# California High-Speed Train Project

## Request for Proposal for Design-Build Services

### Updates to Directive Drawings

12/17/2012 ADDENDUM 7 - RFP HSR 11-16

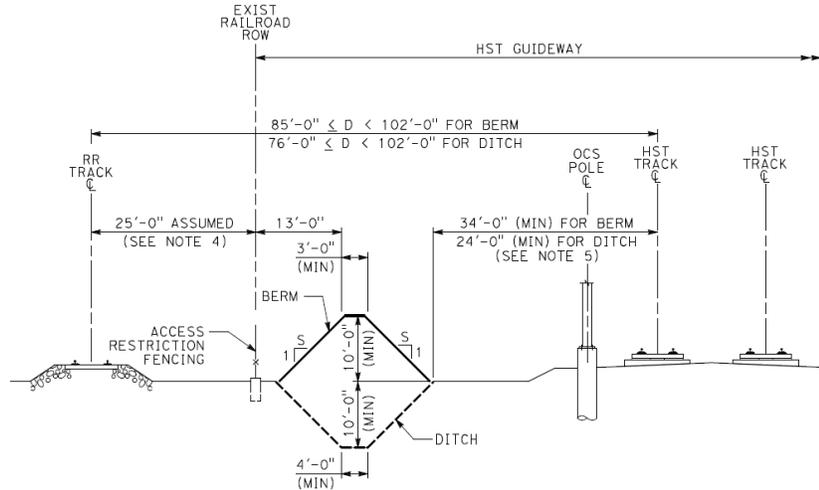
Drawings No.	Change	Page No.	CP01 AD.#
DD-GE-003	<p>Changed Note E, including Sections a) through g) to:</p> <p>“E. CONCRETE COVER</p> <p>1. UNLESS OTHERWISE NOTED, MINIMUM CONCRETE COVER SHALL CONFORM TO AASHTO LRFD WITH CALTRANS AMENDMENTS TABLE 5.12.3-1 WITH THE FOLLOWING EXCEPTIONS:</p> <p>a) UNCASSED DRILLED SHAFTS: 6 INCHES</p> <p>b) CASSED DRILLED SHAFTS WITH TEMPORARY CASING: 4 INCHES”</p>	5	AD.5
DD-GE-003	<p>Changed Note C, Numbers “7”, “8”, and “9”, to Numbers “6”, “7” and “8”.</p>	5	AD.5
DD-GE-003	<p>Changed Note C, Number 6 to:</p> <p>“6. ALL CONSTRUCTION JOINTS IN EARTH RETAINING STRUCTURES AND IN STRUCTURES BELOW THE FINISH GRADE SHALL CONTAIN CONTINUOUS WATERSTOPS, AND SHALL HAVE REINFORCEMENT CONTINUOUS ACROSS ALL JOINTS. HYDROSWELLING STRIPS SHALL BE INSTALLED ON ALL JOINT SURFACES WHICH WILL BE EXPOSED TO EARTH AND PERMANENTLY UNDER THE GROUNDWATER ELEVATION.”</p>	5	AD.5
DD-GE-003	<p>Changed Note D, Number 1, Section c) to:</p> <p>“c) FORMED CAST-IN-PLACE STRUCTURAL CONCRETE:</p> <p>f’c (UNDER GROUND)=4000 PSI</p> <p>f’c (ABOVE GROUND)=5000 PSI”</p>	5	AD.5

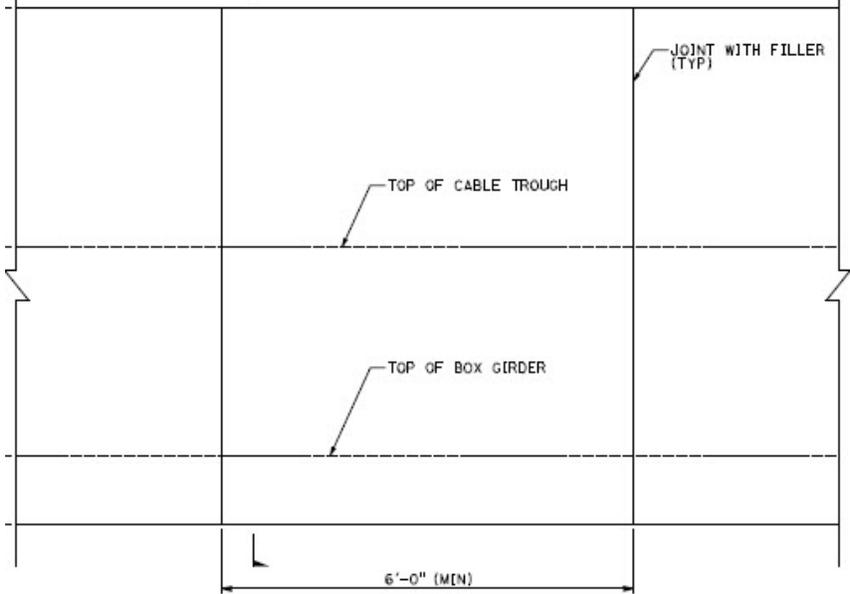
Drawings No.	Change	Page No.	CP01 AD.#
DD-IP-001	Added Note #6: "6. BERM MATERIAL AND COMPACTION SHALL BE SIMILAR TO EMBANKMENT."	37	AD.3
DD-IP-005	Revised Typical Section for Earthen Berm or Ditch; Distance range (for berm) between RR Track centerline and HST Track centerline revised from "86'-0" ≤ D < 102'-0" FOR BERM" to "85'-0" ≤ D < 102'-0" FOR BERM"	41	AD.3
DD-IP-005	Added Note #6: "6. BERM MATERIAL AND COMPACTION SHALL BE SIMILAR TO EMBANKMENT."	41	AD.3

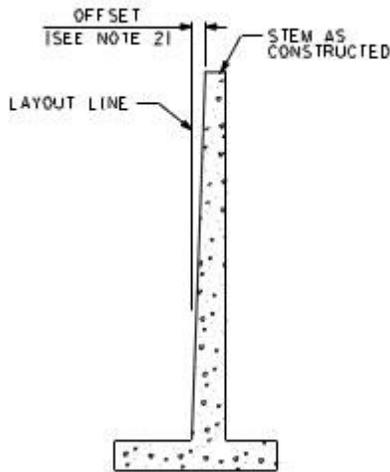
Drawings No.	Change	Page No.	CP01 AD.#
DD-ST-003	<p>Cable Trough Plan: Added "(TYP)" after "JOINT WITH FILLER" and added "(MIN)" after the "6'-0"" dimension shown along the parapet</p>  <p style="text-align: center;"><b>CABLE TROUGH PLAN</b> SCALE: 1"=1'-0"</p>	48	AD.5
DD-ST-004	<p>Cable Trough at OCS Pole Plan: Added "JOINT WITH FILLER (TYP)" callout to the line between parapet walls and changed "(TYP)" to "(MIN)" after the "6'-0"" dimension shown along the parapet</p>  <p style="text-align: center;"><b>CABLE TROUGH AT OCS POLE PLAN</b></p>	49	AD.5
DD-ST-005	<p>Added Note 4:</p> <p>"4. AT CONSTRUCTION JOINTS OF CONCRETE PARAPETS, A JOINT WITH FILLER SHALL BE PROVIDED. IN ADDITION, A PARAPET EXPANSION JOINT SHALL BE DESIGNED AND PROVIDED AT EVERY AERIAL STRUCTURE AND BRIDGE EXPANSION JOINT LOCATION. THE INSIDE FACE OF JOINT OPENING SHALL BE COVERED WITH A GALVANIZED STEEL PLATE SECURELY FASTENED TO THE INSIDE FACE OF THE PARAPET ON ONE SIDE OF THE EXPANSION JOINT WITH A LENGTH OF THREE INCHES MORE THAN THE MAXIMUM JOINT MOVEMENT LENGTH."</p>	50	AD.5
